# IAP Chart Modernization ACM CG #18-02-327

21-01 ACM CG Meeting

NBAA, Access Committee

# Minimums

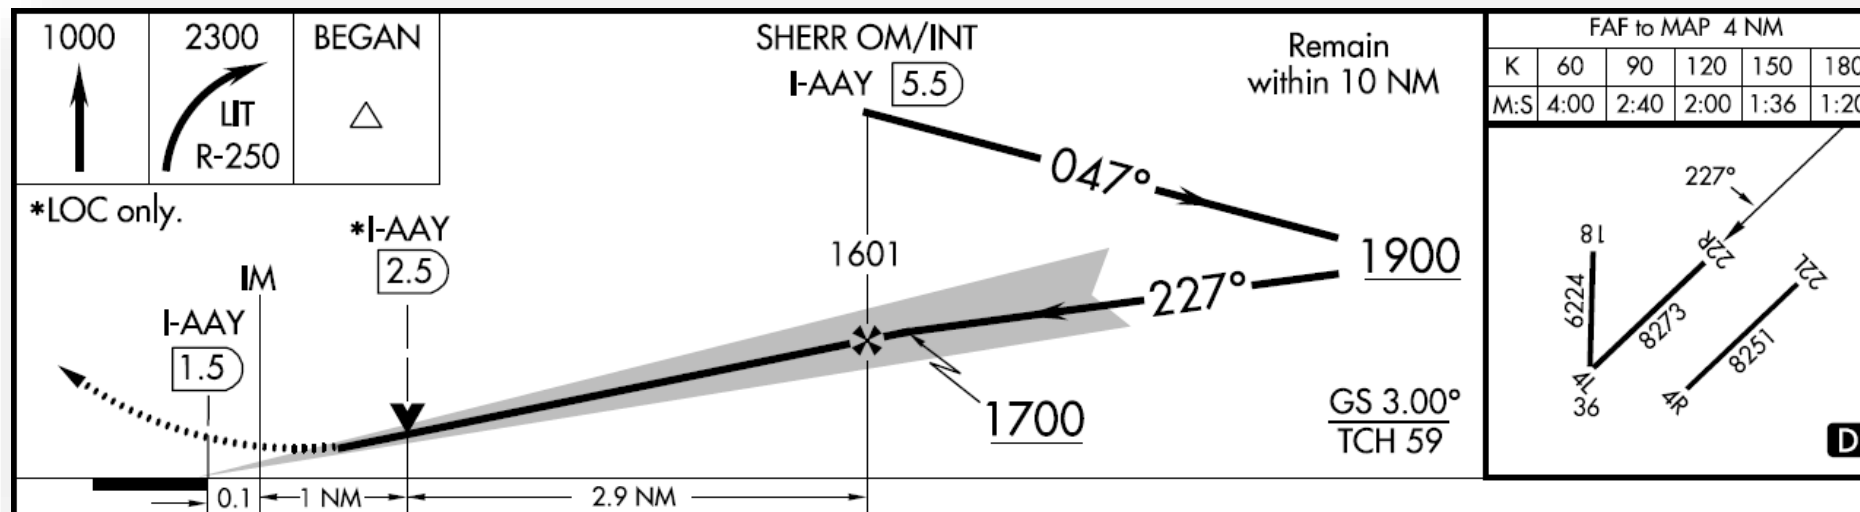
Duplicate visibility in parentheses removed.

- Addition of INOP visibility
- Removal of repetitive SM visibility:

Current:            760-1¼    752 (800-1¼)

Proposed:          760-1¼    752 (800)

## Heliport Depiction

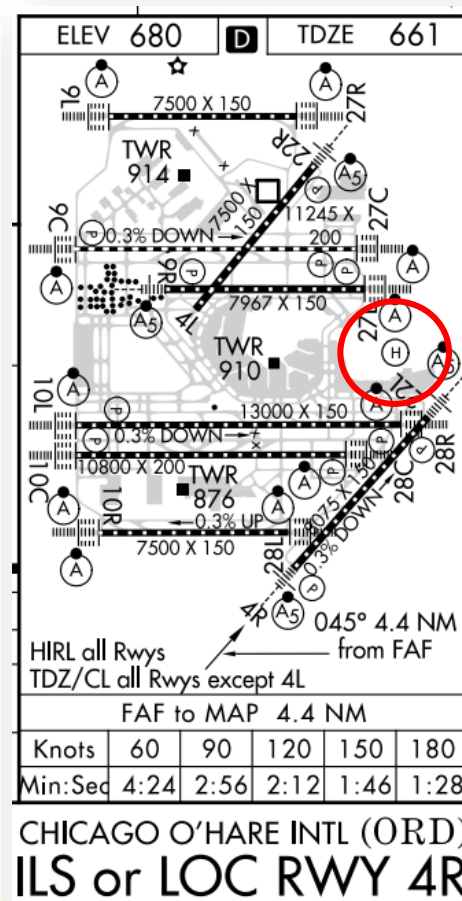
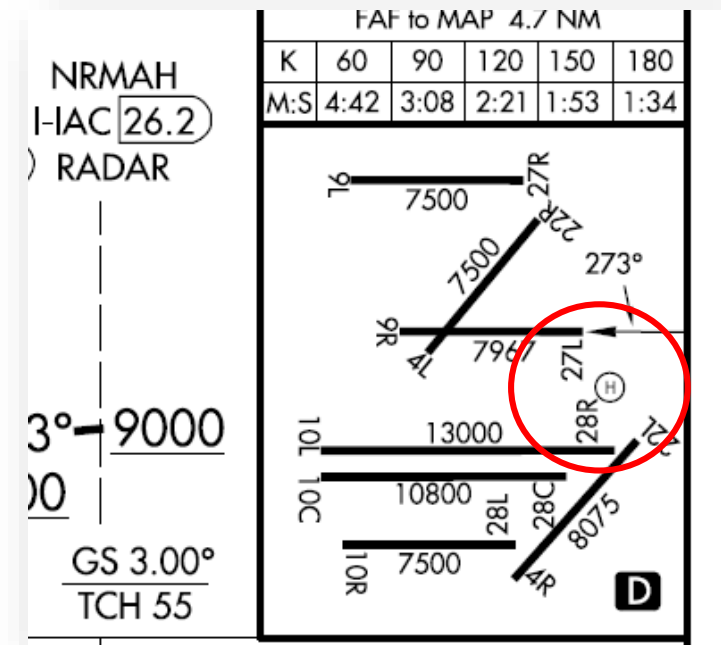
Current Airport Sketch

Can You Find the Heliport?

Proposed Simplified Airport Sketch  
Heliport Depicted When Sourced

❑ ACM-CG Consensus

# Airport Lighting

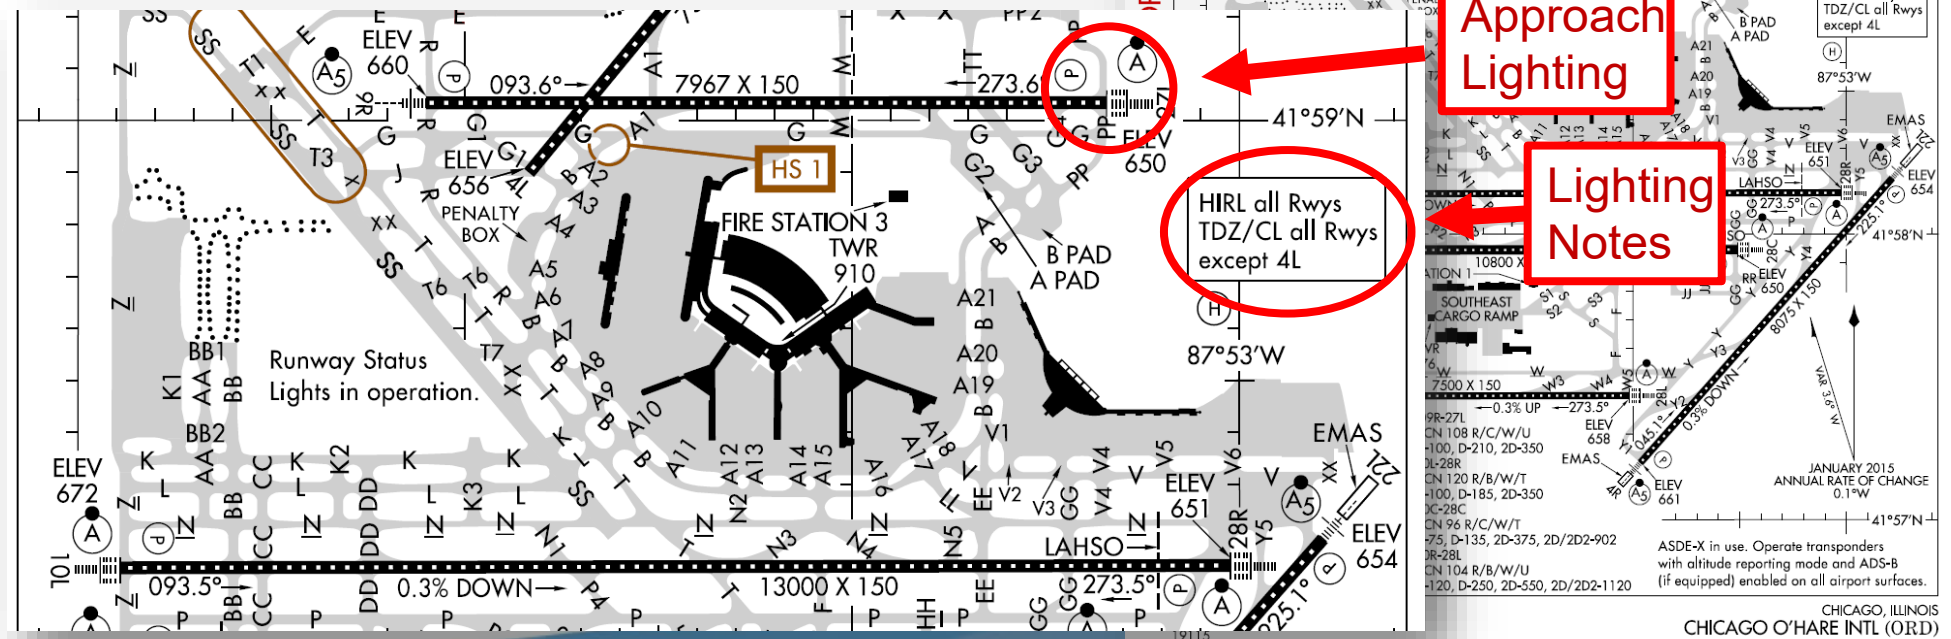
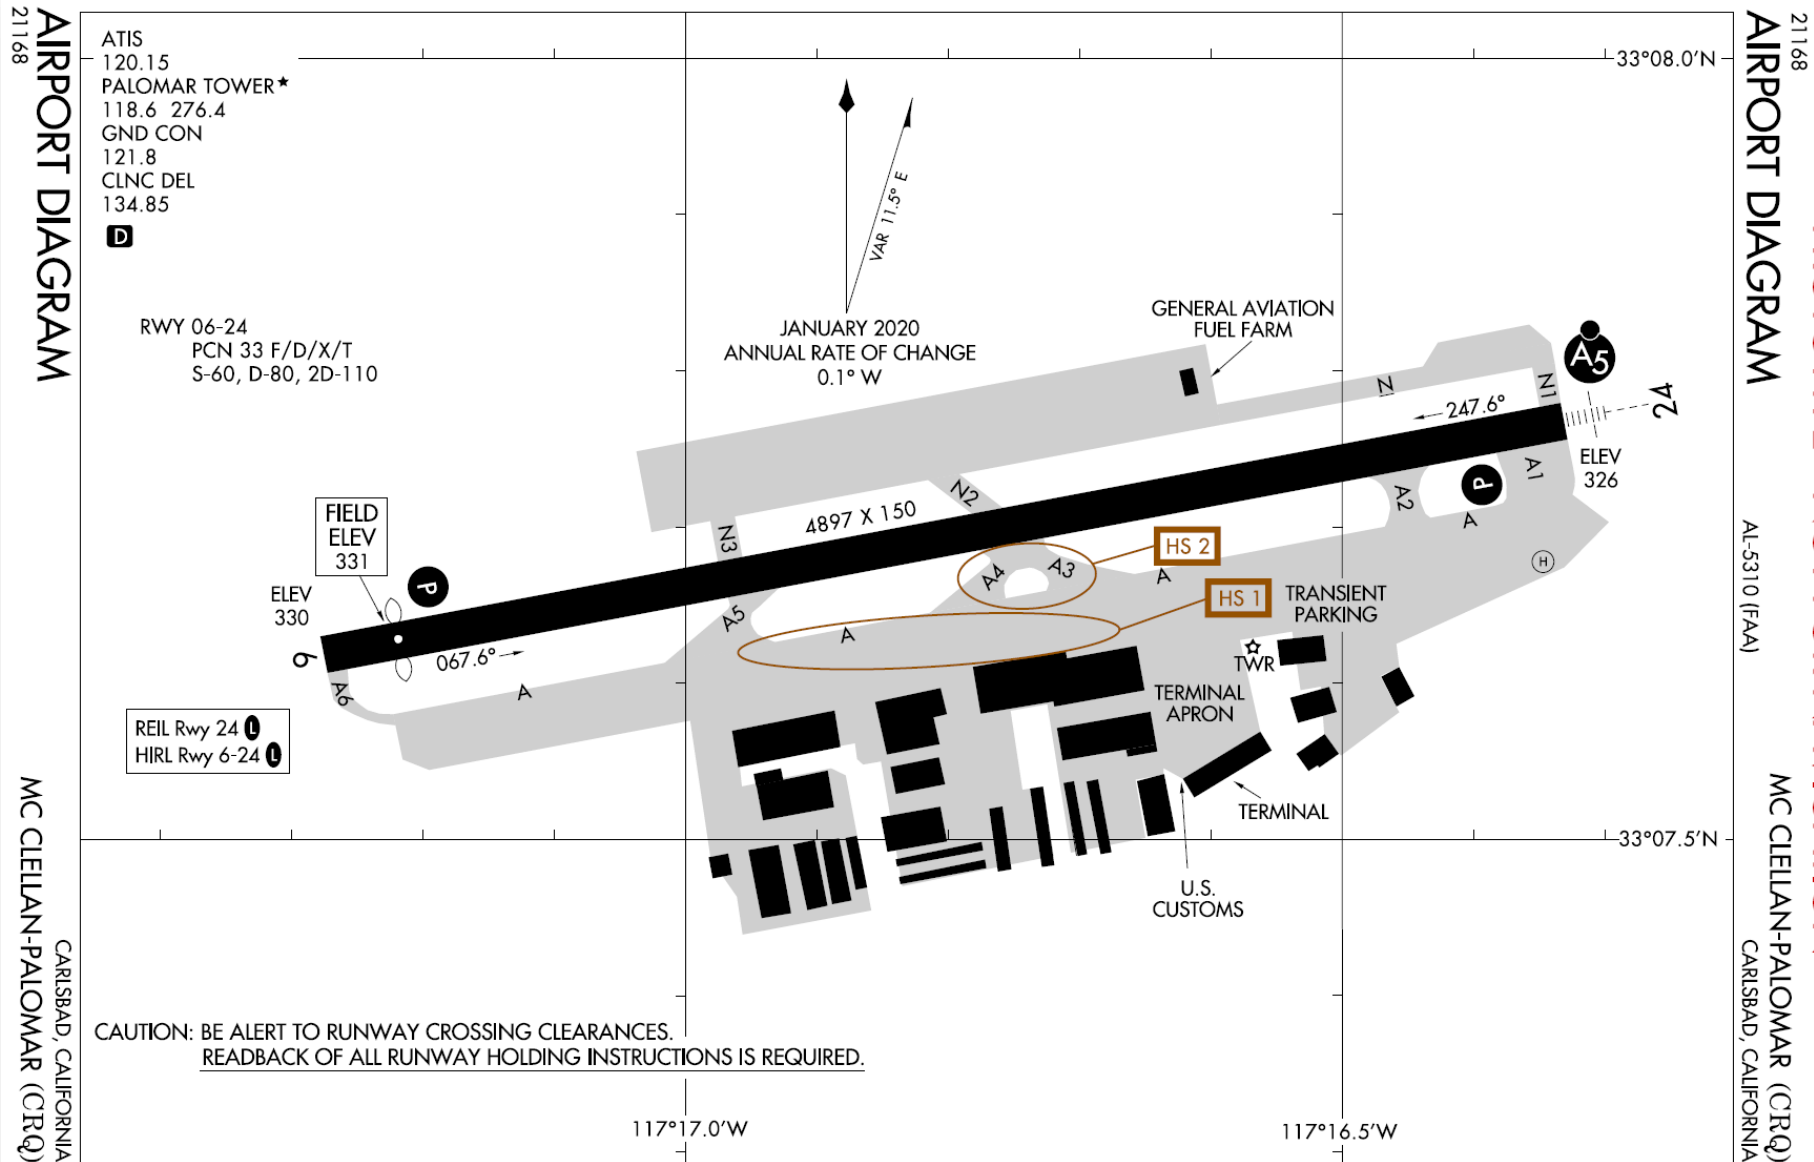
- All airport lighting information previously contained within the airport sketch box will be moved to the Airport Diagram.
- Every airport with an IAP chart in the TPP will have an Airport Diagram.

# RNAV (GPS) X RWY 6

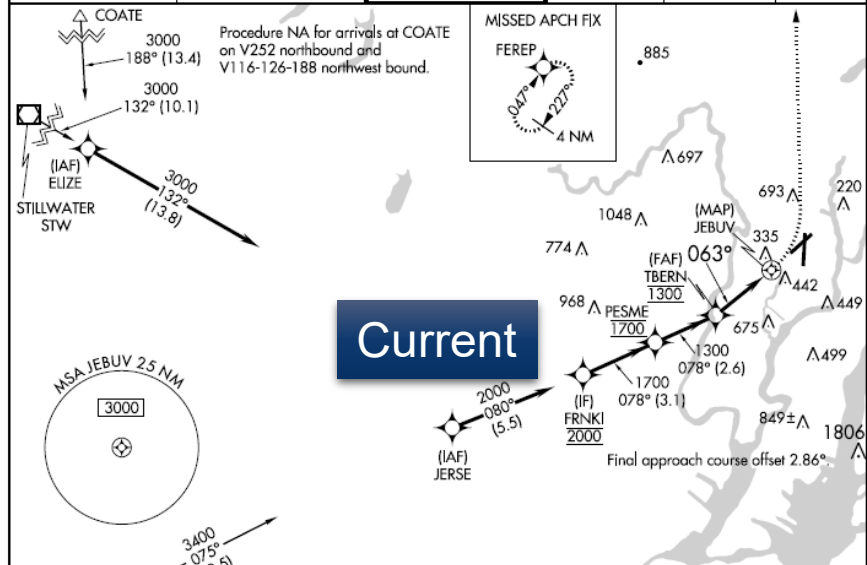
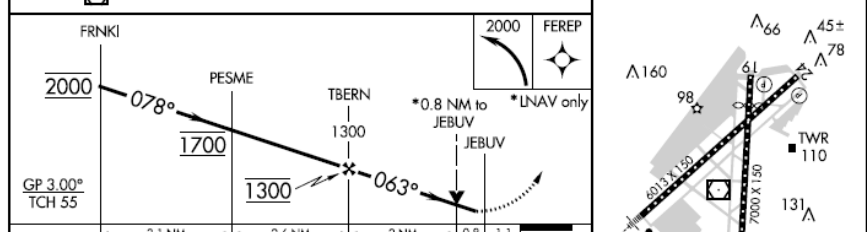
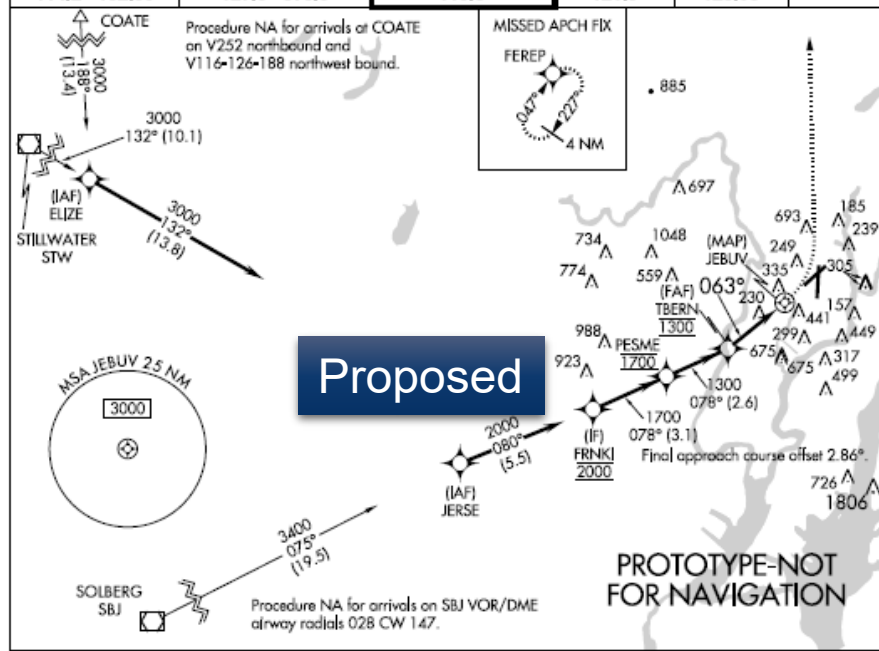
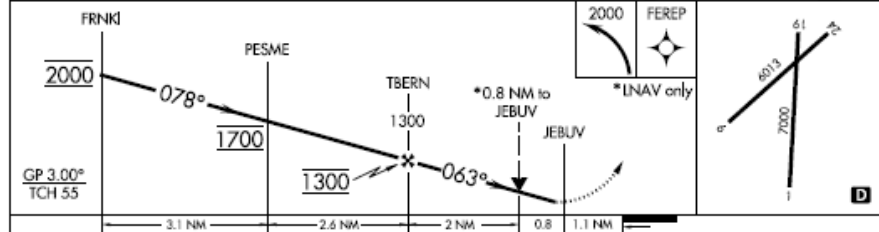
**Current**

**Proposed**

KTEB RNAV (GPS) X Rwy 6

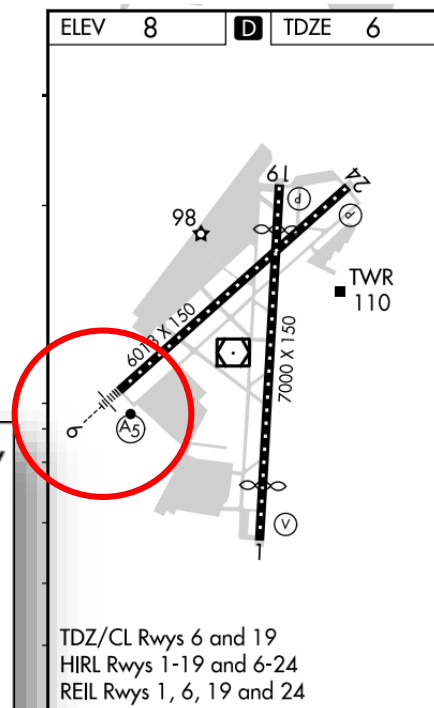
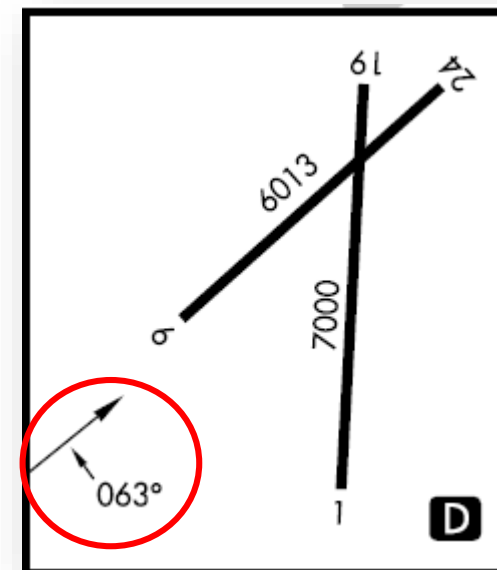
MAP is outside of sketch

Current Airport Sketch

Proposed Simplified Airport Sketch

Should FAA Adopt the NGA/DoD Position?

**FAA Will Not Publish Distance**  
**Only FAC Extended!**

ACM-CG Consensus
